BULLETIN

**BAKERSFIELD CITY SCHOOL DISTRICT  
 BESSIE OWENS E.S. TEMPORARY RELOCATABLES**

BULLETIN NO. ONE (1) DATE: October 11, 2019

CLIENT / PROJECT: BAKERSFIELD CITY SCHOOL DISTRICT  
 BESSIE OWENS E.S. – ELECTRICAL, DATA, & FIRE ALARM FOR TEMPORARY RELOCATABLES

**E203**

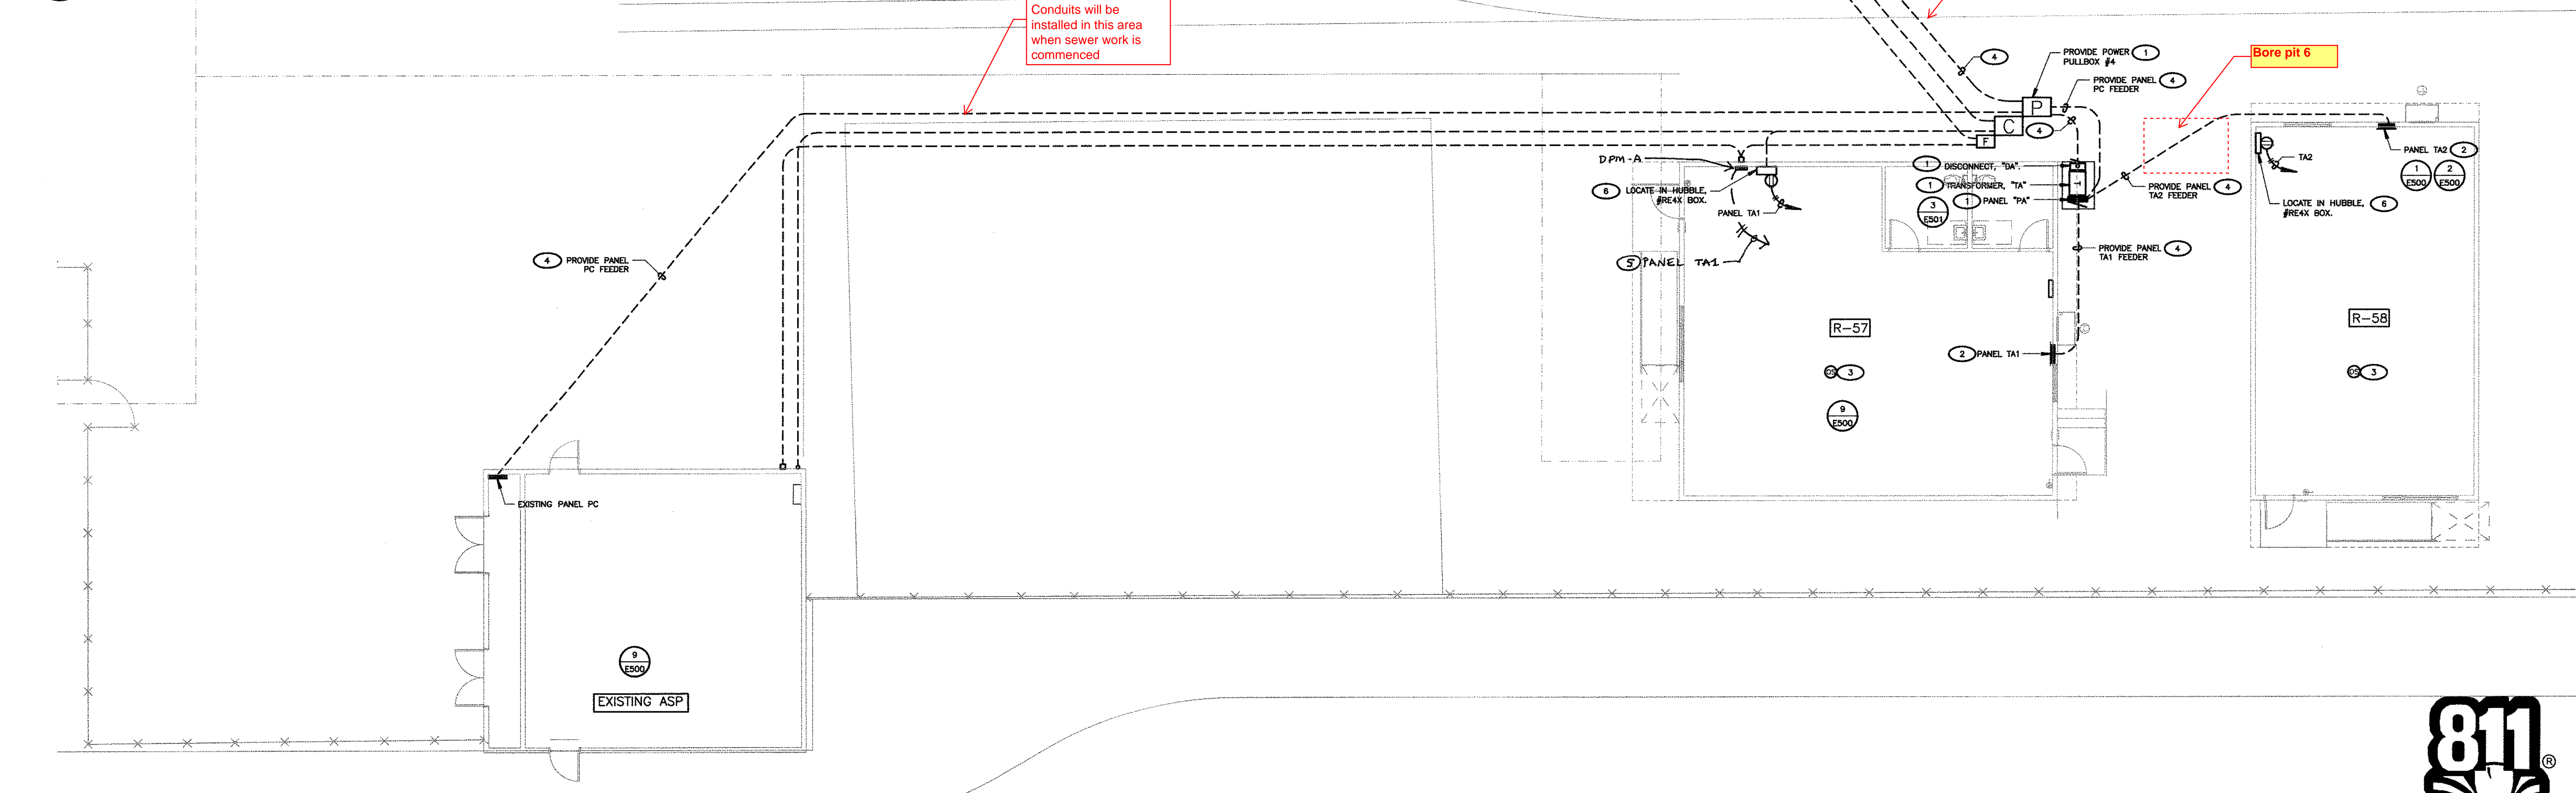
1. All other bore pits will need to be cleaned out (due to previous water inundation), conduits trimmed and turned up.
2. Conduit from west side **Bore Pit 1** to Electrical gear, and new Data Room. See attached Sheet E200, for location.
3. Conduit from **Bore Pit 6** adjacent to the south Temp Admin Relocatables and PRC Relocatable. See attached Sheet E201 and E203.
